Access Compliance Report Public Rights-of-Way (Curb Ramps)

Main Street: DOE_RUN Cross Street: NEWPORT_BLVD Location: SE

ADA ID: RPAT220222175929 Ramp Type: Type 6 - Directional 1 Initial Pass/Fail: Fail Overall Compliance: No Severity Score: 19

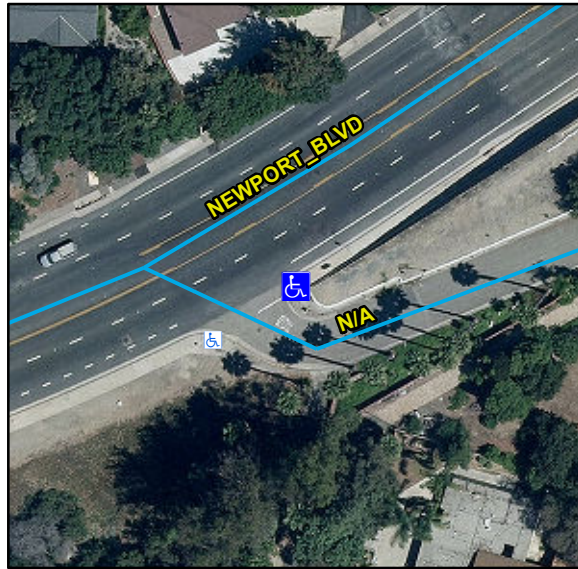
Compliance	Description	Data	Compliance	Description	Data
N/A	Ramp Length (in)	70	N/A	Flare Type LT	
No	Ramp Width (in)	42			N/A
Yes	Ramp Run Slope (%)	4.4	N/A	Flare Slope LT (%)	N/A
No	Ramp Cross Slope (%)	6	N/A	Flare Traversable LT	N/A
N/A	Grade Break	N/A	N/A	Flare Type RT	
N/A	Grade Break Slope (%)	N/A			N/A
N/A	Grade Break Cross Slope (%)	N/A	N/A	Flare Slope RT (%)	N/A
	Addl Para Ramp Left?	N/A	N/A	Flare Traversable RT	N/A
	Addl Para Ramp Right?	N/A	N/A	DWS Provided	N/A
N/A	Landing Present	N/A	N/A	DWS Contrast	N/A
N/A	Landing Length (in)	N/A	N/A	DWS Length (in)	N/A
N/A	Landing Width (in)	N/A	N/A	DWS Full Width	N/A
N/A	Landing Run Slope (%)	N/A		DWS Offset Type	N/A
N/A	Landing Cross Slope (%)	N/A	N/A	DWS Left Offset (in)	N/A
N/A	Landing Movement Obstructed?	N/A	N/A	DWS Right Offset (in)	N/A
	Landing Movement Type	N/A			
N/A	Landing Shared	N/A			
N/A	Marked Crosswalk 1	No	N/A	Clear Space	N/A
	Crossing 1 Direction	SW	N/A	Clear Space To Crosswalk (in)	N/A

Marked Crosswalk 1 Width (in)	N/A			
N/A	Ramp Inside Crosswalk 1	N/A			
	Crossing 1 Slope (%)	3.8			
	Crossing 1 Cross Slope (%)	8.5			
N/A	Gutter Ponding	N/A	N/A	Curb Slope	13
Yes	Gutter Lip Height (in)	0		Road Run Slope (%)	N/A
N/A	Gutter Run Slope (%)	N/A		Road Cross Slope (%)	N/A
N/A	Gutter Cross Slope (%)	N/A		Parallel Ramp Side	N/A
Yes	Overall Surface Condition	Acceptable	Yes	Perp Joint Present	Yes
	Cross Gutter Present?	No		Spandrel Present?	No
	Replace Cross Gutter?	N/A		Replace Spandrel?	N/A

Remove & Replace Entire Ramp.

R304.5.1, R304.5.3, STD 1115
